# Workshop on the engineering of in- monolith neutron optics

## Part I Report and Recommendations

**Held at PSI 11 April 2017**

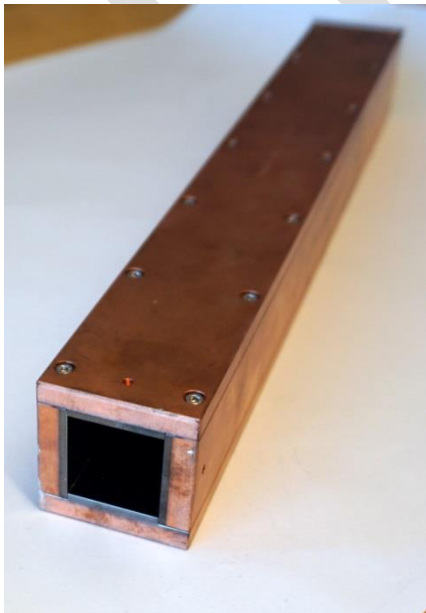
The proposed three-sectioned NBOA is endorsed by the panel.

2 millimeters of gap around the NBOA is considered largely sufficient for alignment between optical units and to the insert access.

Two chicanes should be incorporated to reduce streaming paths. Chicanes should be separated by at least 1000mm. The height of these steps should be calculated to ensure overlap of at least five times the gap in the worst case installed scenario.

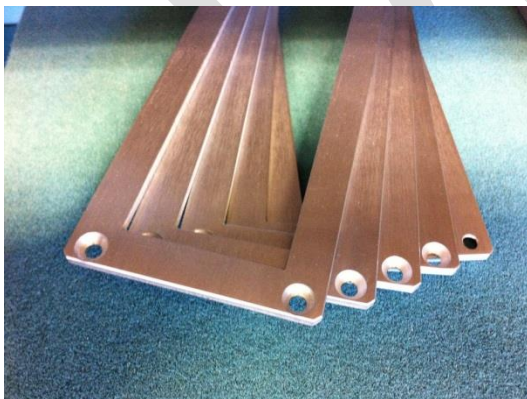
The proposal to employ high M-value coatings and to employ copper substrates in this radiation field is a ‘first of kind’ which implies a degree of risk. Despite the number of short term tests which have been carried out into the performance of coatings and this substrates but currently no long time tests have been done nor will become available before a decision must be made.

Taking into account both the novelty of the application and the critical nature of components to the facilities instrument it is considered that the risk of coating failure in service to be significant to a number of guides and that measures should be adopted to mitigate this risk.

As a result, to reduce the risk of coating failure use in-monolith, it is recommended to restrict the use of coatings in this application to those in which significant operational experience exists.

As a result it is recommended to cap coatings of in-monolith optics in a general case to  $M = 4.0$

The use of coatings above this value should be restricted to positions downstream of the first 1000mm and reduced to small surfaces. Uses should be justified by a demonstration of the performance gain over  $M=4$  in and that the loss of performance in the event of potential failure permit the instrument to continue meaningful operation.

**Comment:** A similar policy is proposed for the current PSI upgrade. At FRM II currently installed metal substrate guide coatings are within this scope. The value of the cap is question of appreciation the difficult to repair of the installations and the degree of risk of loss of scientific production considered acceptable by the facility management.

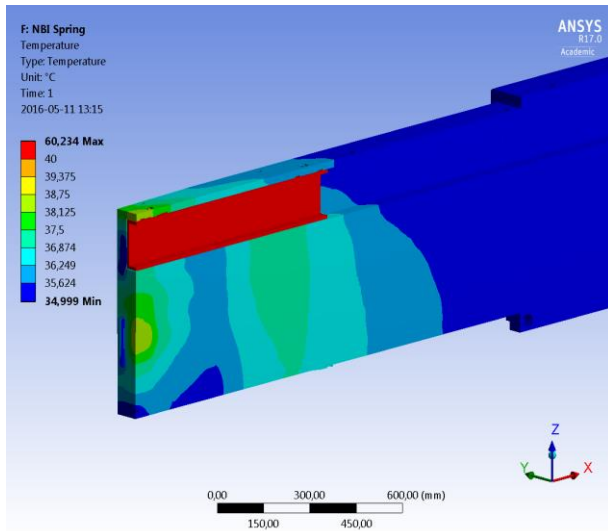
The use of a borated mask on the front face of copper substrates is not considered necessary to avoid substrate damage. Its use should be considered to reduce the level of activation of components in service and which may result in reduced waste handling and disposal costs.

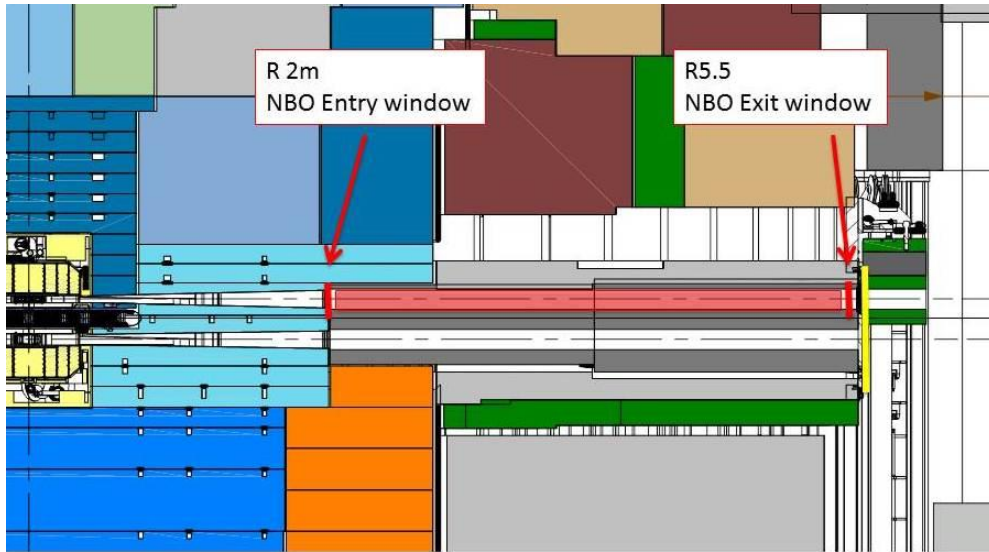
The cooling of optical elements through passive means ie without fluid circulation are strongly recommended, to ensure reliable and maintenance free long term operation.

The proposed solution through of housing the NBOA within a helium filled cavity within the cooled insert is supported as an effective and robust solution.

A gaseous atmosphere is seen as a valuable contribution to the cooling of silicon wafers within the optical elements and as a method to improve the rejection of heat from the optical units to the cavity walls. If water cooling cannot be avoided, it use limited to as few circuits as possible, reducing the risk of leaks.

Use of local cooling pads to supply additional cooling is supported if required (simulations are needed). The contribution of alignment type leaf-springs to heat transfer should be considered as a simple solution if the need for additional cooling is shown to be minor.
